July 23 2020

RE: Peninsula Heights Residential

2 SOUTH PARCEL STREETSCAPE SECTION
 SCALE: 1/4"=1'-0"

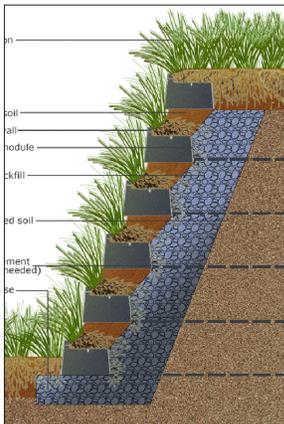
1. The previous review letter noted that some edges of Campus Drive at the North Area had limited setbacks and little room for buffering landscaping. The South Area had a greater setback and more landscaping, but there was no information provided at that time to indicate any privacy walls or the general streetscape appearance.

The applicant has now refined their approach to the site's new retaining walls, and provided Campus Drive edge sections and visual examples - see below.

North Area: Mid-Site

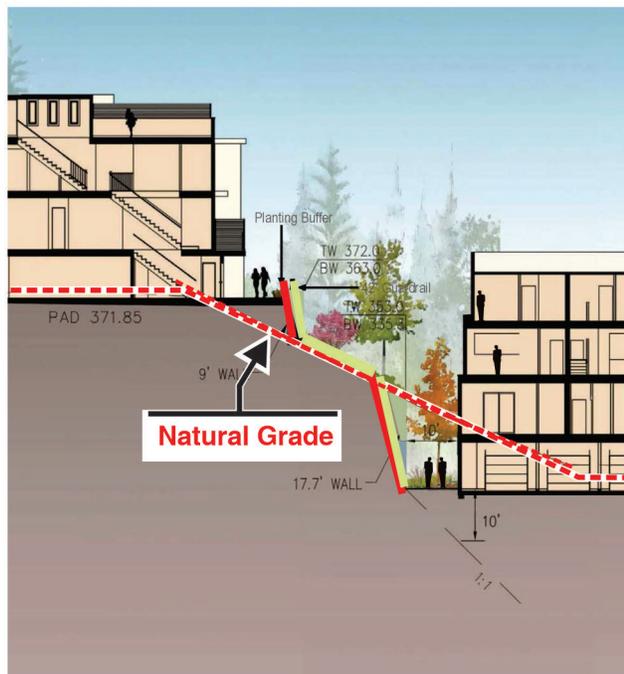
2. A concern was raised related to the degree to which the topography of both the North and South Areas are being altered. Both areas are currently divided into two flat pads separated by heavily landscaped slopes. The current plans envision the removal of most of the natural landscaping, and the sculpting of the land forms to increase the amount of flat land area to accommodate more residential units. This will result in some tall retaining walls in areas that are today gradual landscaped slopes.

Given the topography of the site, there were inherent site challenges to meet the Planning Commission's request of 1) wider array of unit types 2) maintain or increase density 3) increase functional open space and 4) maintain or increase the parking ratio. The applicant believes the project addresses the requests of the community and Planning Commission. In order to meet these requests, the project relies on a retaining system for hill stability. Further, the existing hillside stability relies on methods used during the 1960s and is inferior to the retaining system being proposed which will materially improve the hillside performance during a seismic event. This will improve the public health and safety for the project and existing neighbors. To mitigate the visual impacts of a retaining system, the applicant has proposed a four-layer landscaping approach along the frontage of Campus Drive that will enhance the current experience along the street frontage. Today, there is only one layer of landscaping. Additionally, the retaining system that is proposed for the project is fully plantable, providing native landscaping across the face of the wall, mitigating the "tall wall" perception. This proposed system includes a batter vs. vertical retaining wall which helps the retaining system mimic the existing hillside - see illustrations on page 4.
